HAMBLIN & BOWEN SUBDIVISION

The plat illustrates the proposed 2 lot, 117 acre \pm subdivision which is located at 7600 Bellingrath Road (West side of Bellingrath Road, 145' \pm South of Jeanette Avenue, extending to the CSX Railroad Right-of- Way). The applicant states that the subdivision is served by public water and public sewer.

APPLICATION NUMBER 11 DATE October 7, 2010

DETAIL SITE PLAN

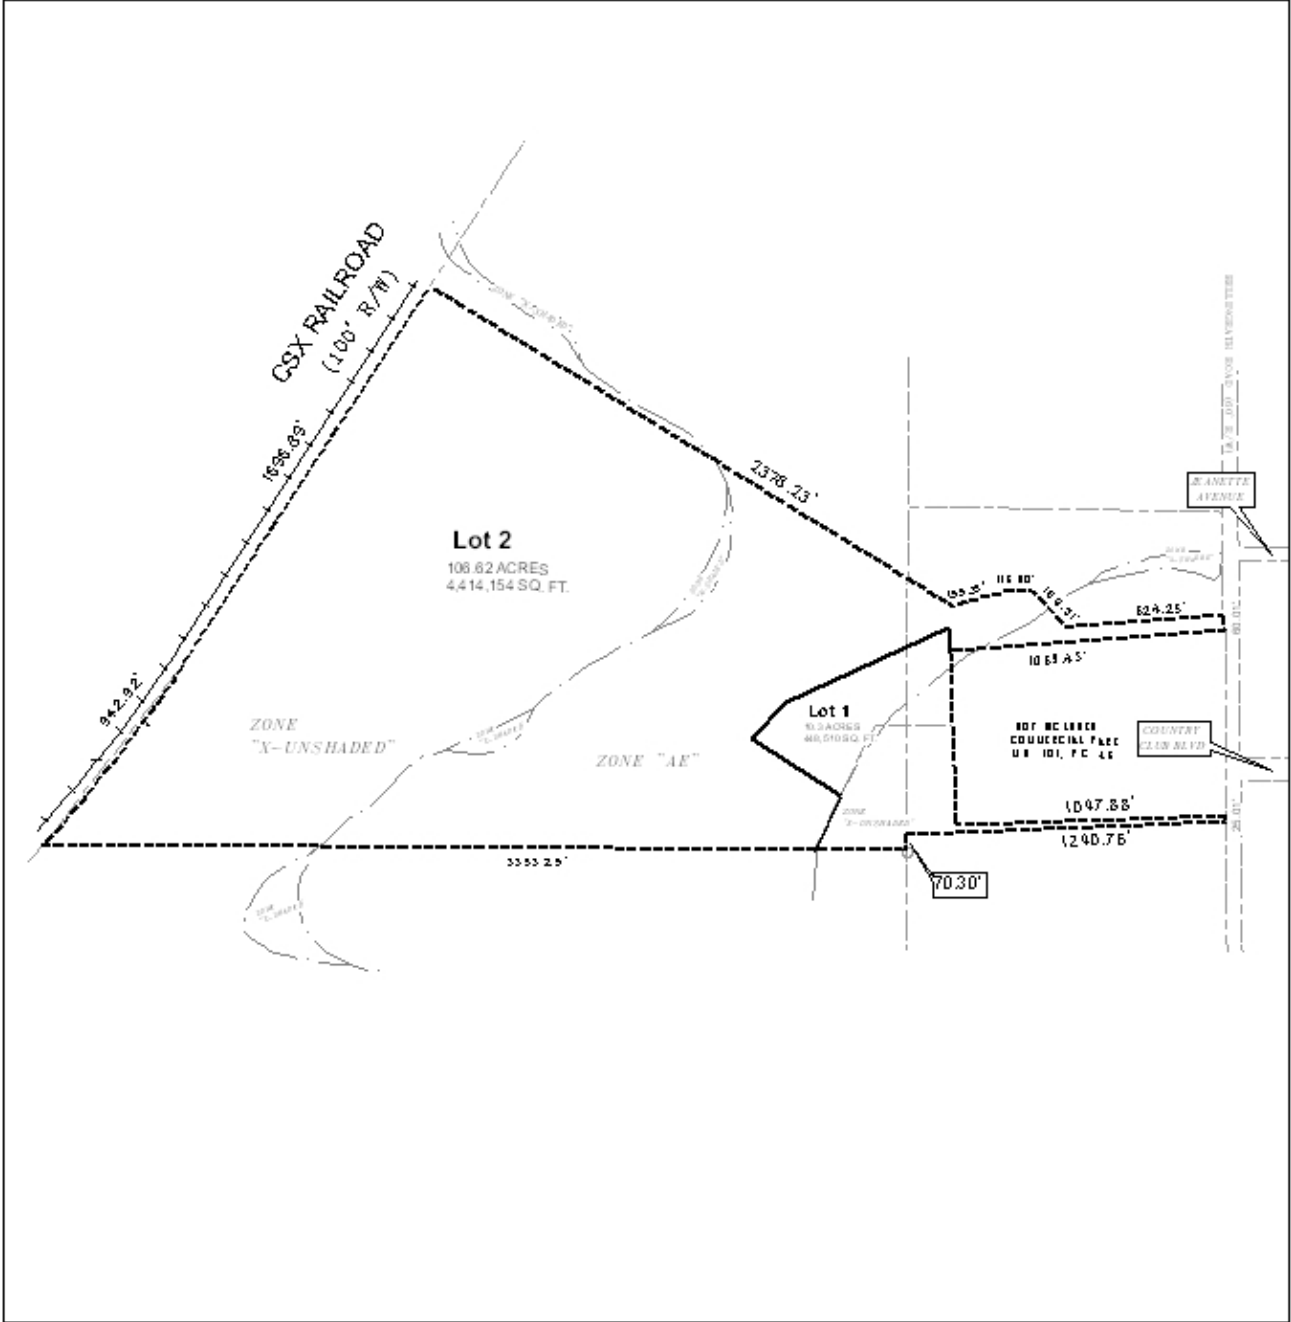
The proposed lots meet the minimum size requirements as regulated by Section V.D.2. of the Subdivision Regulations. However, both of the lots are flag shaped. The proposed Lot 1 does not meet the requirements of Section V.D.2. of the Subdivision regulations regarding minimum width, however, the proposed lot does meet the minimum 25-foot width for a flag-shaped lot. The proposed Lot 2 does meet the requirements of Section V.D.2., but, as the lot is exceptionally deep, it does not meet the requirements of Section V.D.3. of the Subdivision Regulations regarding maximum width to depth ratio. Given the nature of the design of this Subdivision, and the fact that the Commission has made it policy not to approve flag-shaped lots unless they are a family subdivision, it should be noted that, had this Subdivision Application come before the Commission for original approval, staff's recommendation would have been for denial. However, because these lots, and their flag shapes were already previously approved, and because the amount of street frontage or number of lots is not changing, waivers of the affected sections of the Subdivision Regulations may be appropriate. Given the aforementioned waivers, a note should be placed on the Final Plat stating that there will be no further subdivision of either lot until such time as additional access to an adequate public right-of-way is provided.

The lots have frontage on Bellingrath Road, a major street as shown on the Major Street Plan component of the Comprehensive Plan. The plat depicts the right-of-way of Bellingrath Road in this area as being 60-feet. The major street plan requires a right-of-way of 100 feet for the roadway. The 2001 Planning Commission approval stipulated that adequate right-of-way be

dedicated to provide 50 feet from the centerline of Bellingsrath Road, however, the 2001 approval only covered the proposed Lot 2. The proposed Lot 1 was partially created under the 1997 approval, and no right-of-way dedication was required. Further, the right-of-dedication affecting the proposed Lot 2 does not appear to be depicted on the submitted plat. As such, dedication sufficient to provide 50 feet from the centerline of Bellingsrath Road should be required.

The 25-foot minimum building setback line is not depicted on the preliminary plat, and this should be shown on the Final Plat. The setback line for the proposed Lot 1 should be depicted where the lot meets minimum frontage requirements, outside of the flagpole portion. The lot area size is depicted on the plat, as such, and this information, with any correction necessary due to any dedications, should be retained on the Final Plat.

As Bellingsrath Road is a planned major street, access management is a concern. The site is already partially developed; with each lot currently have one curb cut. As such, each lot should be limited to one curb cut each, with the size, design, and exact location of all curb cuts to be approved by County Engineering and conform to AASHTO standards.

A portion of both of the lots appear to be located within FEMA designated floodplains. The presence of floodplains indicates that the area may be environmentally sensitive; therefore, the approval of all applicable federal, state and local agencies would be required prior to the issuance of any permits or land disturbance activities.

- 1) placement of a note on the Final Plat stating that there shall be no future resubdivision of either lot until additional frontage on a public right-of-way is provided;
- 2) dedication sufficient to provide 50 feet from the centerline of Bellingsrath Road;

- 3) depiction of the 25-foot minimum building setback line along all right-of-way frontages, with the 25-foot minimum building setback line for Lot 1 being depicted outside the flagpole portion of the lot, where the lot meets minimum frontage requirements;

- 4) labeling of the lot area size, in square feet, or provision of a table on the Final Plat with the same information, with changes as necessary due to dedications;

- 5) placement of a note on the Final Plat limiting each lot to one curb cut each to Bellingrath Road, with the size, design, and location of all curb cuts to be approved by Mobile County Engineering and conform to AASHTO standards;
